#### **ADDENDUM #3**

PROJECT: CODESTACK ACADEMY

REF. # : ARCH PROJ. No. 2023-04

DATE: 27 November 2024

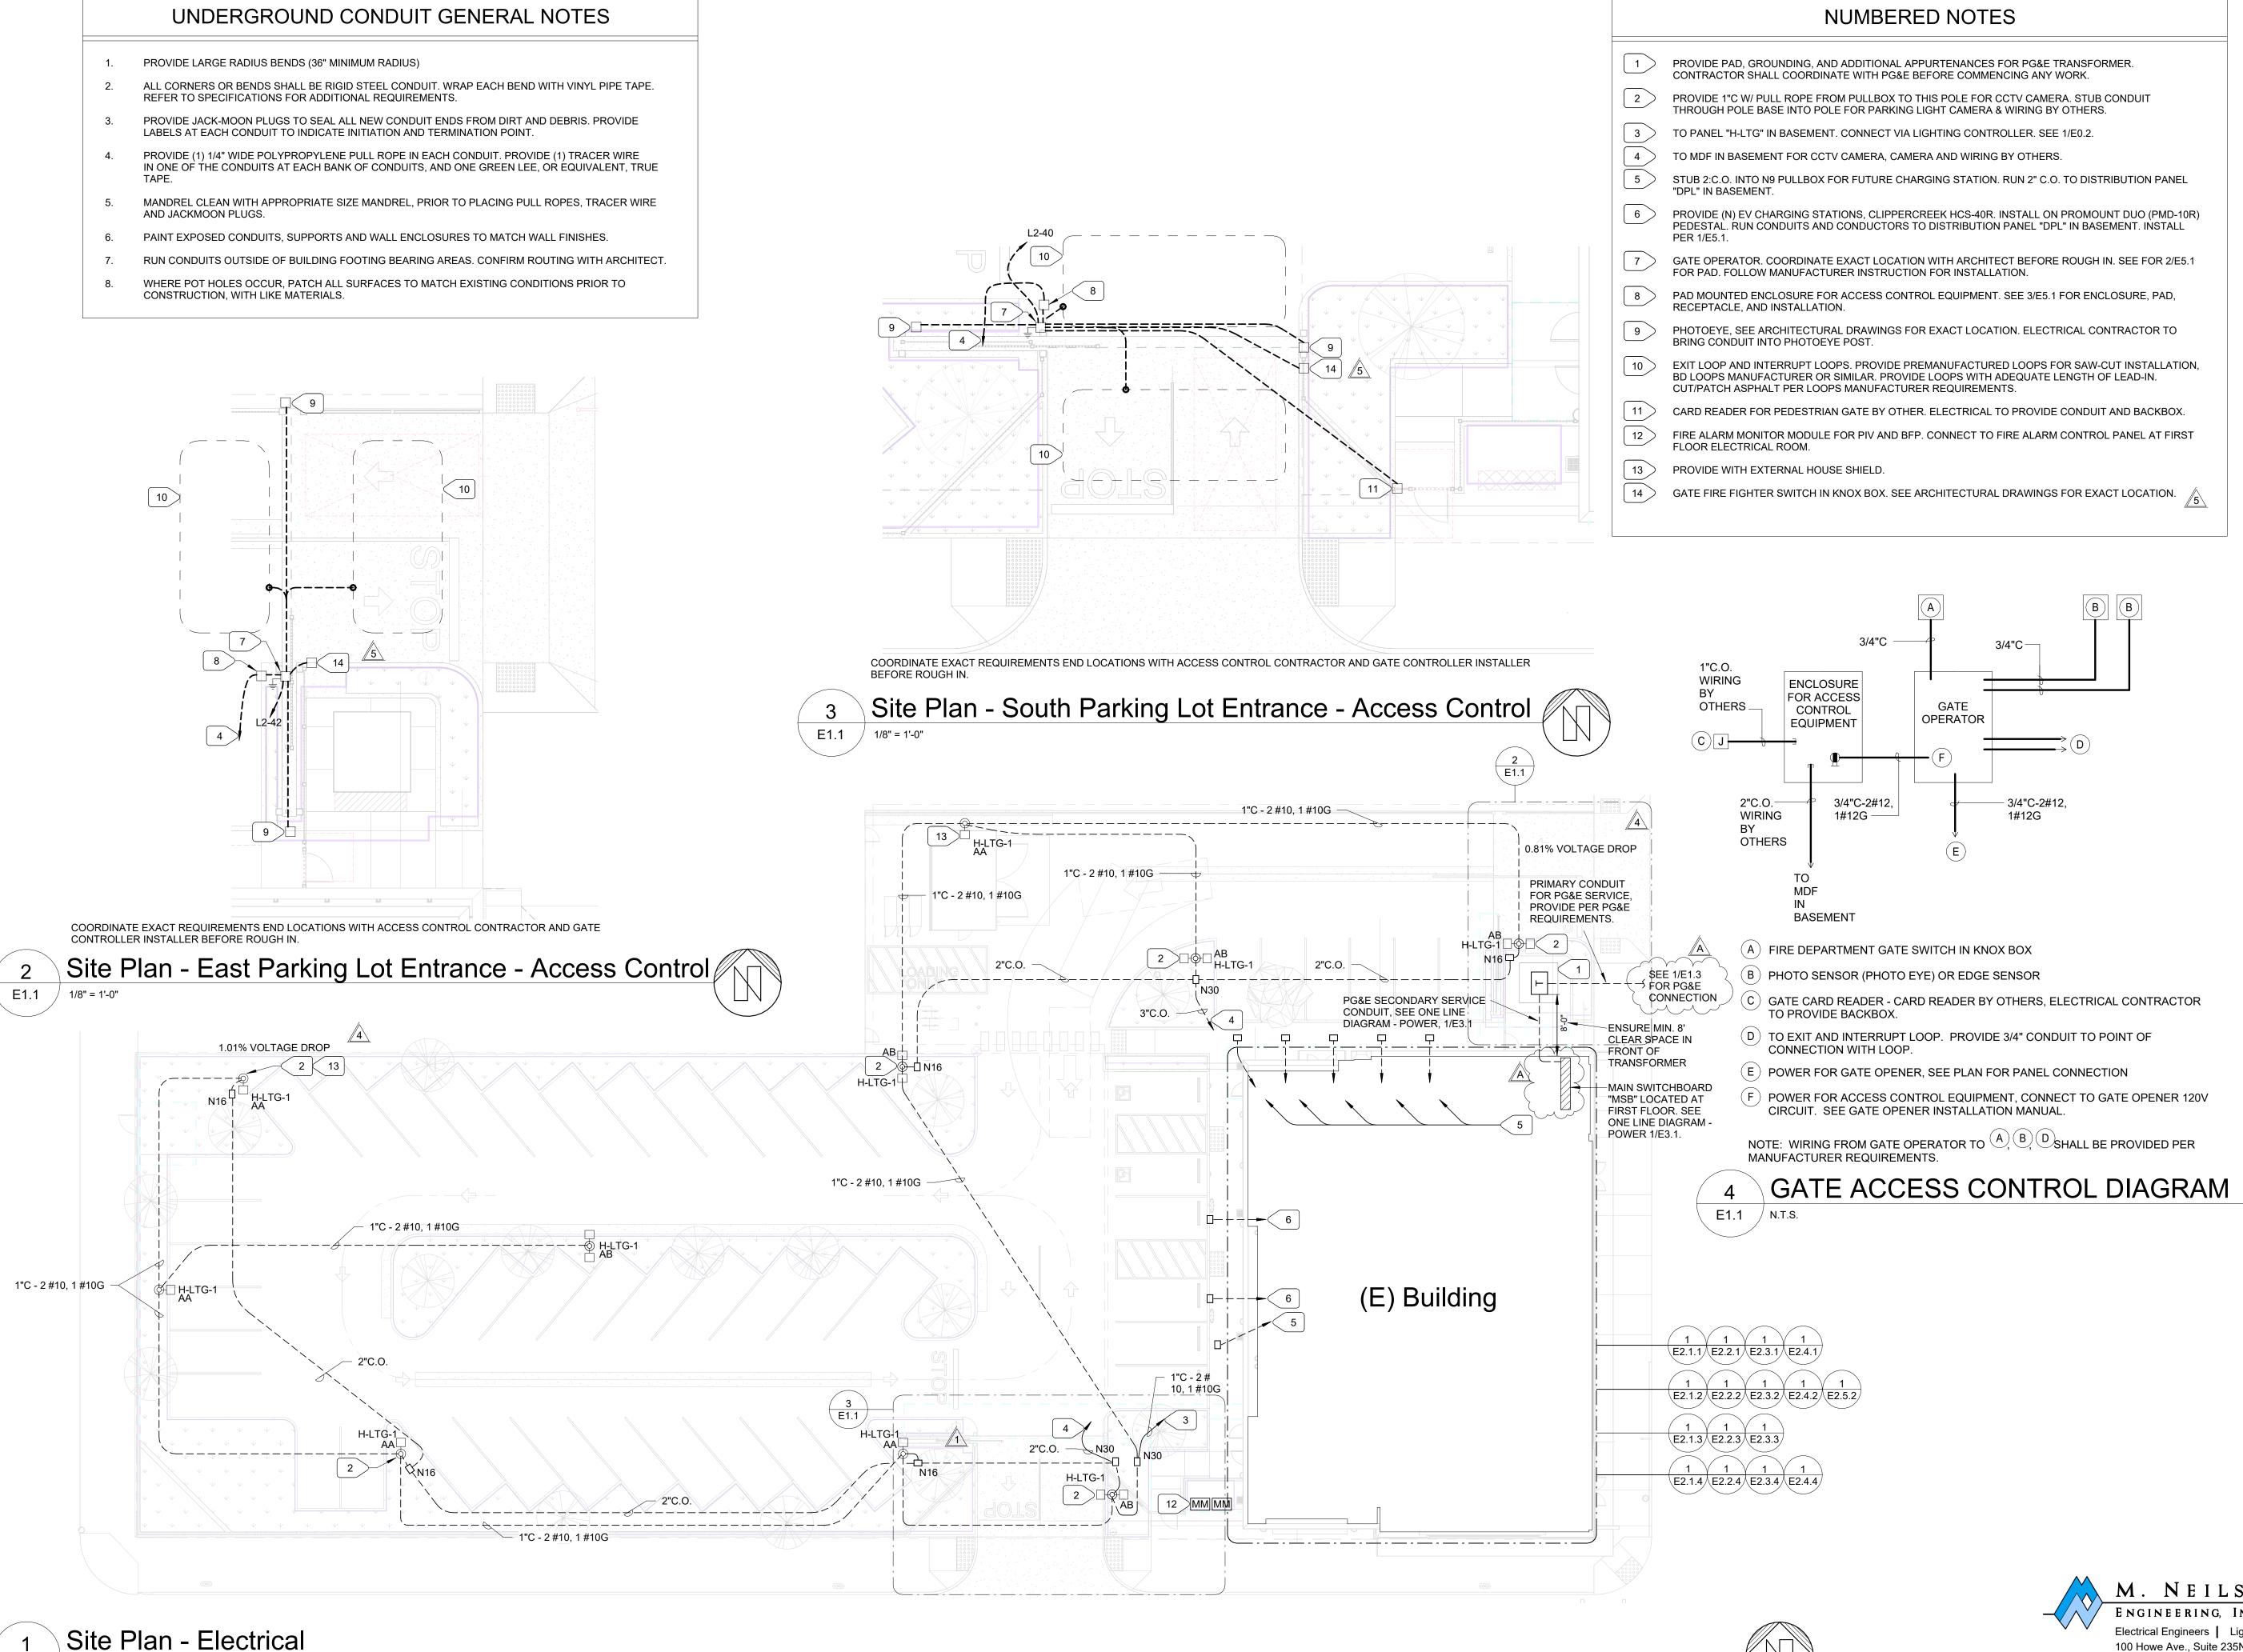
#### ITEM 1 SHEET P1.0

Revisions to vent location due to coffee reconfiguration.

SITE PLAN -**ELECTRICAL**

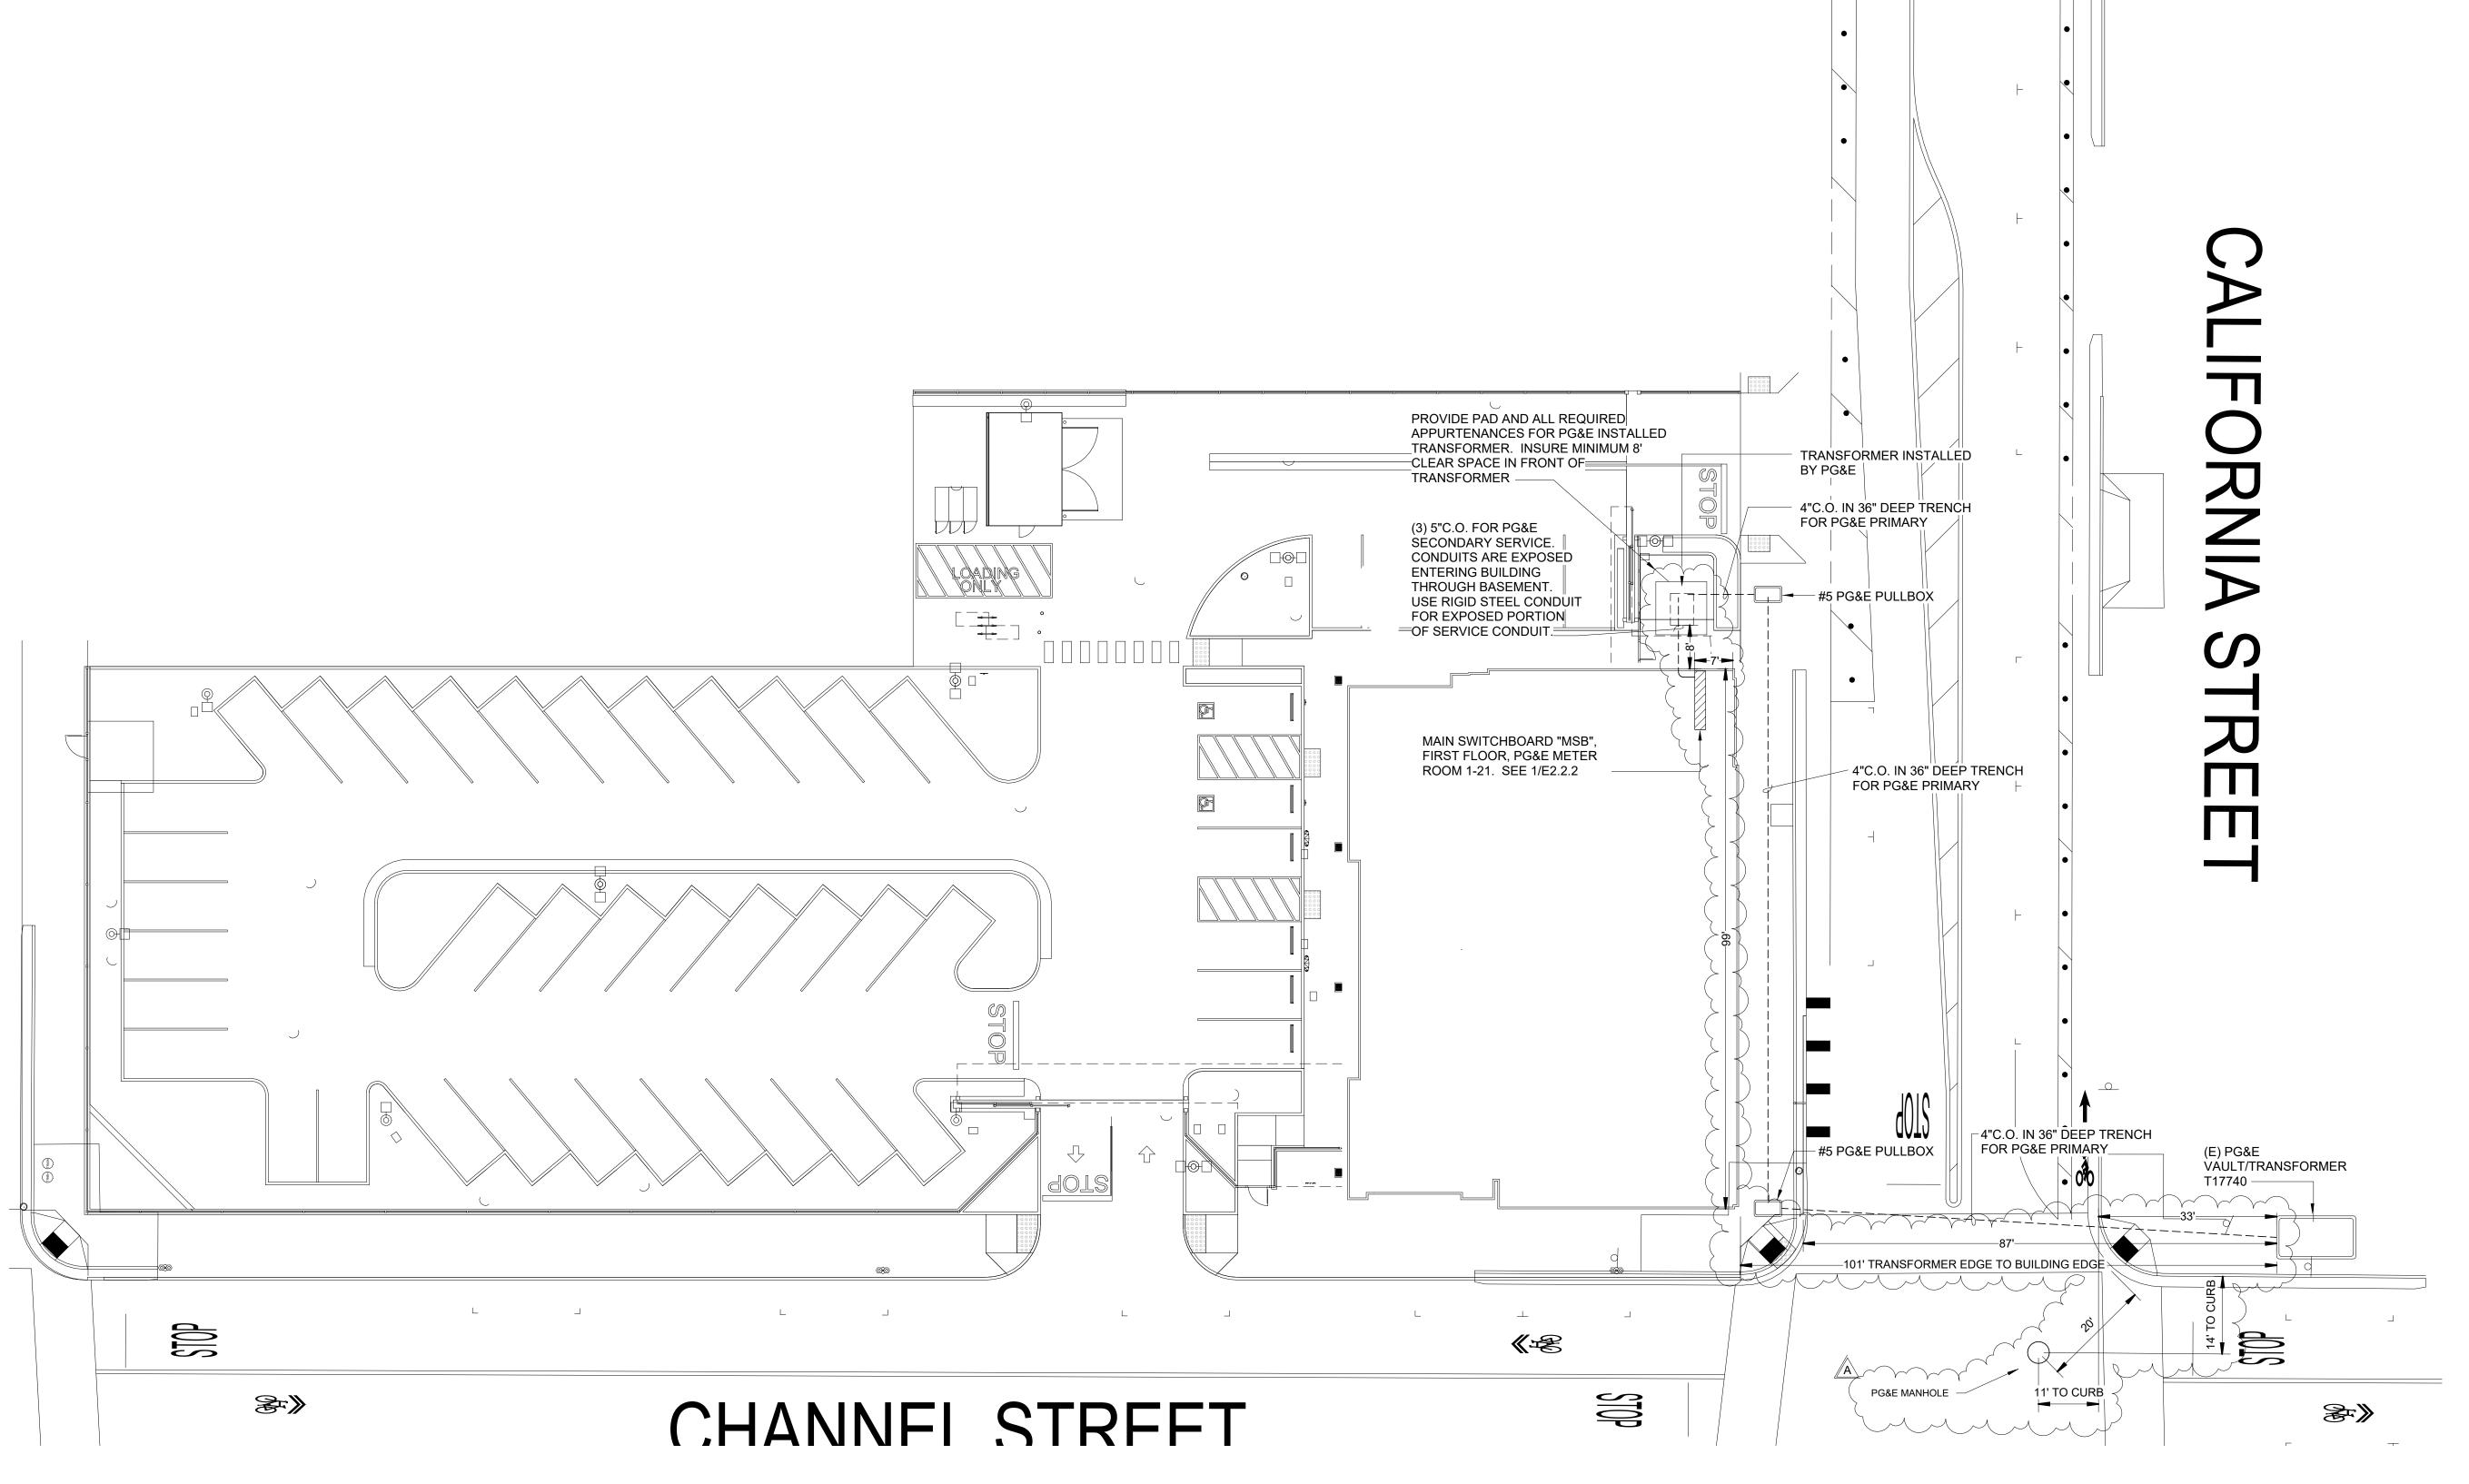
ITEM 1 SHEET E1.1

Reference to sheet 1/E1.3 and correct location of Main switchboard

SITE PLAN - PG&E CONNECTION

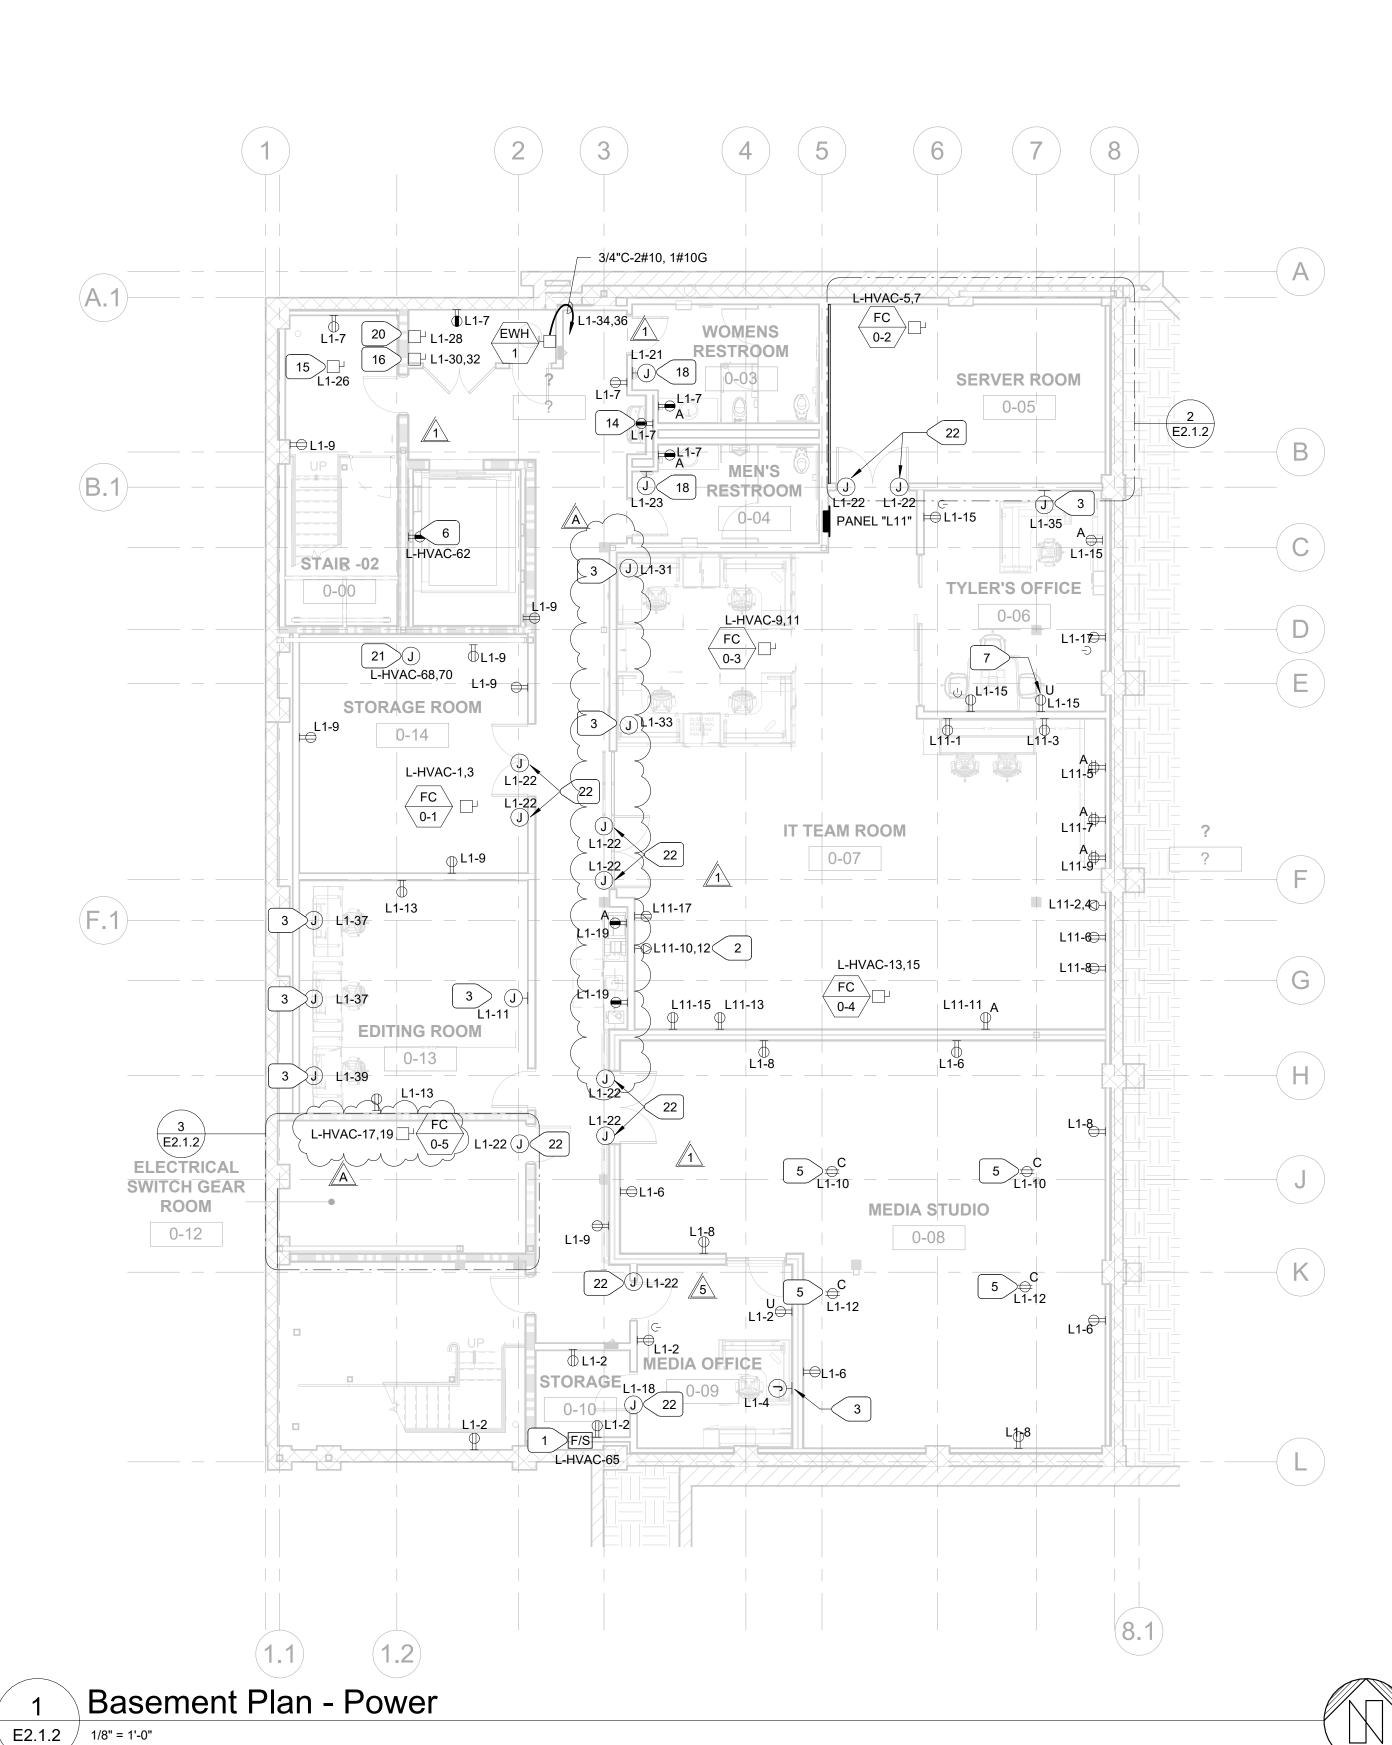
ITEM 2 SHEET E1.3 – new sheet

PGE street connectivity diagram with dimensions.

3 Electrical Switchgear Room
E2.1.2 1/4" = 1'-0"

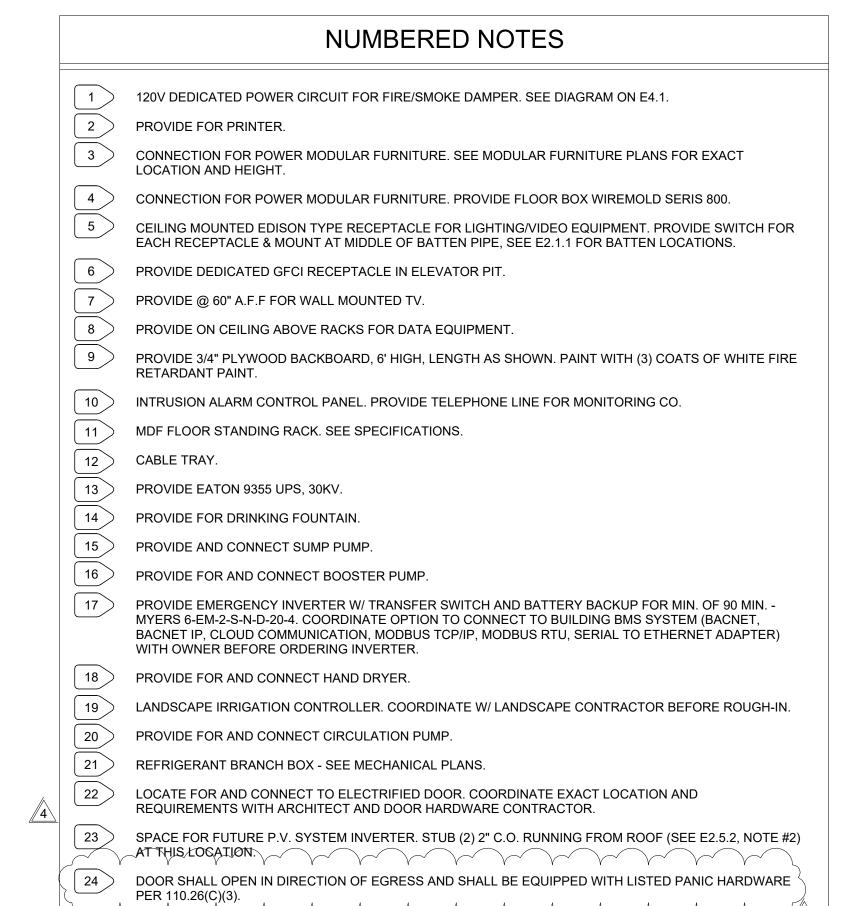
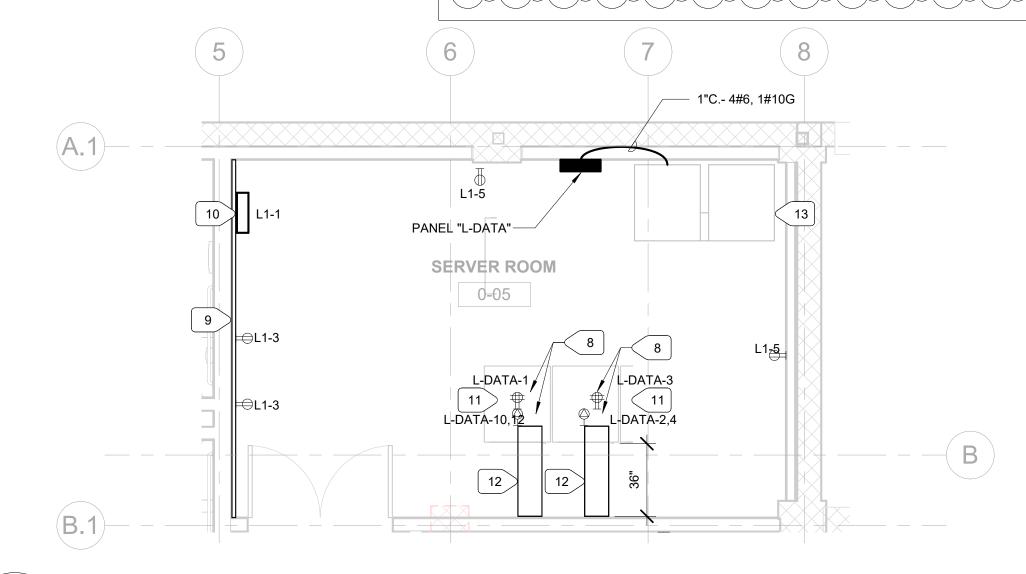
ITEM 3 SHEET E2.1.2

Revisions to equipment locations in electrical switchgear room per plancheck comments.
